Dennis Family Corporation
Submission to Draft Casey Fields South (Employment) & Devon Meadows PSP
Amendment C295case to the Casey Planning Scheme

The following letter sets out submissions by DFC in response to proposed Amendment C295 to the Casey Planning Scheme – the Casey Fields South (Employment) & Devon Meadows (CFS&DM) PSP.

Figure 1 - Casey Amendment C295case – Public Acquisition Overlay – Schedule 4 (VPA)

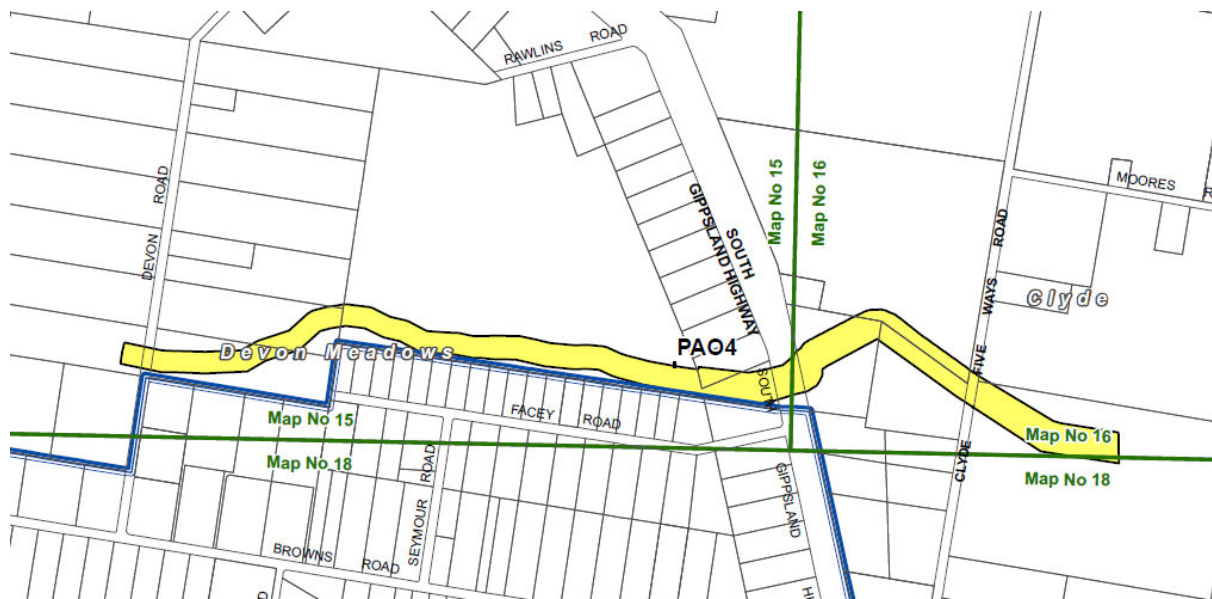
The draft PAO – Schedule 4 (PAO4) shows that the proposed diversion waterway extends significantly east beyond the Clyde Fiveways Road and onto land within the Clyde South PSP precinct area (See Figure 1, below).

The diversion waterway thus moves stormwater flows from the south of the Devon Meadows PSP and into the Clyde South PSP precinct. The amendment documents are largely silent on how these flows are proposed to be conveyed and attenuated beyond the end of the PAO4 extent, however it seems clear that a retarding basin will need to be constructed somewhere near the southern boundary of the Clyde South PSP along Manks Road, prior to water discharging into the Westernport Green Wedge.

Figure 2 - Appendix C – Preliminary concept drainage strategy plan - Figure C1 (Source: GHD Interim report – Casey Fields South (Employment) and Devon Meadows Precinct Structure Plan – Preliminary Concept Drainage Strategy, 21 February 2025).

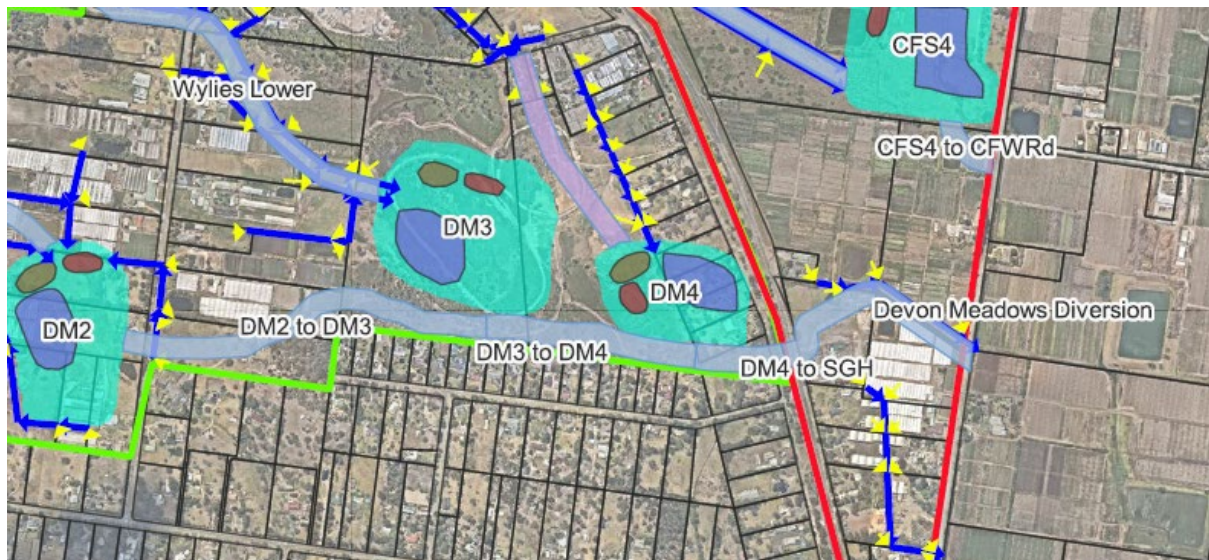
In fact, the PAO4 extends well beyond the waterway shown in the GHD concept drainage strategy plan upon which the drainage services scheme is based (See Figure 2, below).

The GHD report also suggests the potential need for additional land take within the future Clyde South PSP area to manage cumulative flood peaks within the proposed Clyde Five Ways Road Drainage Services Scheme (DSS). This scenario arises from the merging of two outfalls (O1 and O2) from the CFS&DM PSP east of the Clyde Fiveways Road, within the Clyde South precinct:

The reliance upon land within the Clyde South PSP to ameliorate stormwater flows from the CFS&DM PSP is concerning in the absence of a further information detailing how stormwater will be managed within the PSP. While Melbourne Water has agreed to fund additional works within the Clyde South precinct, including land acquisition associated with the PAO4, there remains a dearth of other information relating to implementation of the proposed drainage scheme. For example, it is unclear how the Clyde Five Ways Road Drainage Services Scheme (DSS) is going to operate to best practice standards in the interim, that is, until resolution of the above issues within the Clyde South PSP area.

Submission 1: We request clarification of the full impacts of the proposed Clyde Five Ways Road Drainage Services Scheme (DSS) upon the Clyde South PSP.

Figure 3 – PSP Plan 9 Infrastructure and Development Staging (VPA) – highlights added

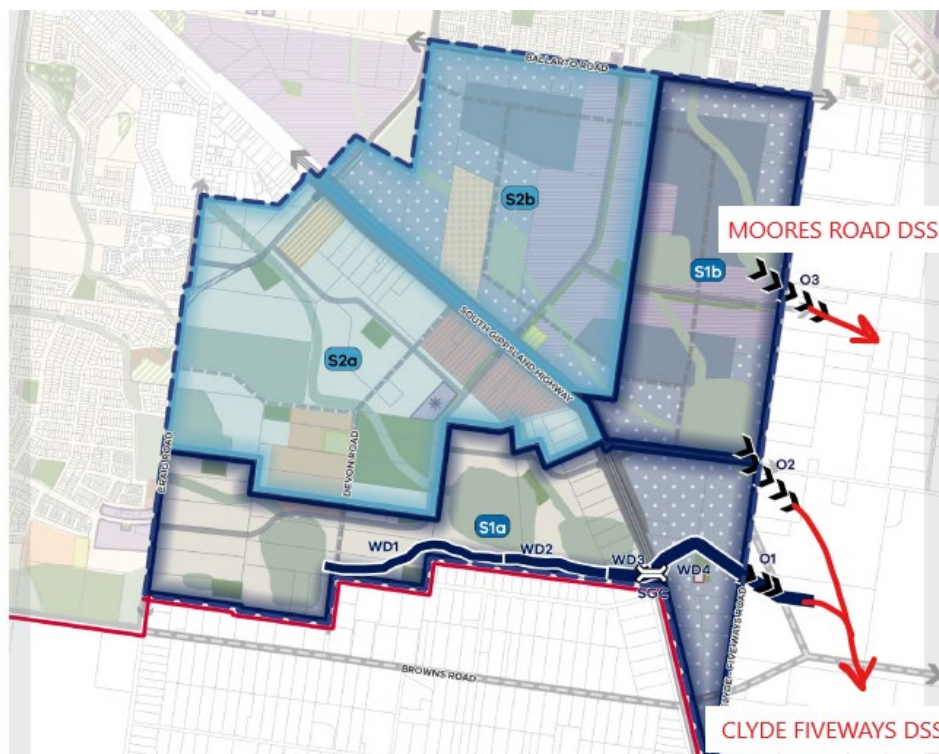
We are concerned that the catch-all approach taken to provision of those items of infrastructure identified in Table 8 and Plan 9 conflates drainage infrastructure across two separate and independent DSS', namely the Clyde Five Ways Road DSS and the Moores Road DSS. Project items O2 and O3 are identified in Stage S1b but outfall into the separate schemes (See Figure 3).

This will effectively mean that land within the Moores Road DSS in Stage S1b will not be able to develop until all infrastructure items identified in Table 8 are delivered. However, this land only requires construction of outfall O3 (and other upstream drainage infrastructure in the Moores Road DSS) to develop. This highlights difficulties in imposing such an inflexible staging regime over the PSP.

While we acknowledge the importance of ensuring the timely delivery of key enabling drainage infrastructure identified in Plan 9, we fear that the imposition of such a universal and inflexible sequencing of stages and infrastructure projects, particularly given the land fragmentation of the PSP, may inadvertently stall all development in the PSP.

Submission 2: We request greater flexibility be written into the infrastructure and development staging requirements in Section 7.3 of the CFS&DM PSP. Requirements should be revised to permit some flexibility in the order of delivery of the identified staging infrastructure where it can be demonstrated that an alternative deployment of key infrastructure can meet DSS outcomes, to the satisfaction of the relevant water authority.
